SUBJECT: Additional Questions Review for Water Right 63-34660

SUBJECT: Licensing Review of Water Right 63-34660

Re: Eagle Sewer District Water Right 63-34660 Beneficial Use Field Report

STATE OF IDAHO
DEPARTMENT OF WATER RESOURCES
BENEFICIAL USE FIELD REPORT

THEORETICAL HORSEPOWER EQUATION WORKSHEET (cjh 1/92)

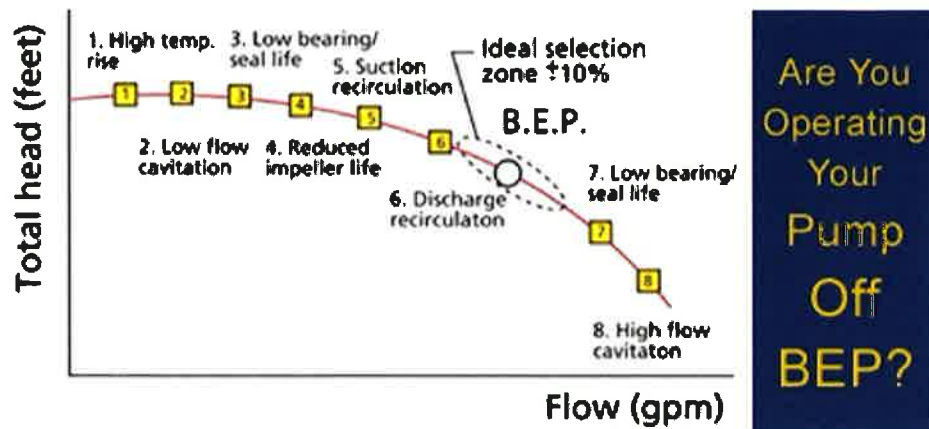
Examiners Notes: The certified water right examiner stated that this pump can run at approximately 1.00 cfs. The pump curve supplied shows that the pump isn't designed to run beyond a flow of approximately 320 gpm. However, the fire suppression system is designed to operate at 10 psi, and the lift is very small at 30 feet. When this particular pump is operating at 320 gpm, the efficiency rating according to the pump curve is approximately 43.4 %. According to our theoretical equation, the pump should actually be pumping 257 gpm at 100 feet of Total Dynamic Head (TDH) with the 43.4% efficiency shown in the pump curve. That is approximately a 20% difference our equation and the pump curve, so there is significant room for error in these calculations. Using our equation, I estimated the efficiency at 320 gpm and 100 feet head to be approximately 54% efficient. According to our equations, the pump would have approximately 40.3 % efficiency at the diversion rate and total dynamic head for the fire flows.

CONCLUSION: This pumping system was designed to have a minimum diversion rate of approximately 100 gpm, and 220 gpm to 260 gpm at maximum efficiency. Maximum efficiency according to the pump curve is about 60% for the pump and motor. The pump installed was oversized to allow for the fire protection needs. It obvious to attain the 450 gpm needed is possible, but the efficiency of the system is greatly diminished at that high of a diversion rate. Although the efficiency would be diminished, the pump should still be able to maintain a 450 gpm diversion rate for a short time. It is recommended that pumps only be operated for short periods below 50% efficiency, and that they should never be operated below 20% efficiency. It is expected that operating this pump at this low of efficiency rating for an extended time would cause the pump to cavitate and quickly break down. However, the fire protection portion of this permit will only be used in the case of an emergency. Although the pump would probably fail if it was run for an extended period, it would be able provide the 1.00 cfs flow rate for a short period of time before it began to self destruct.
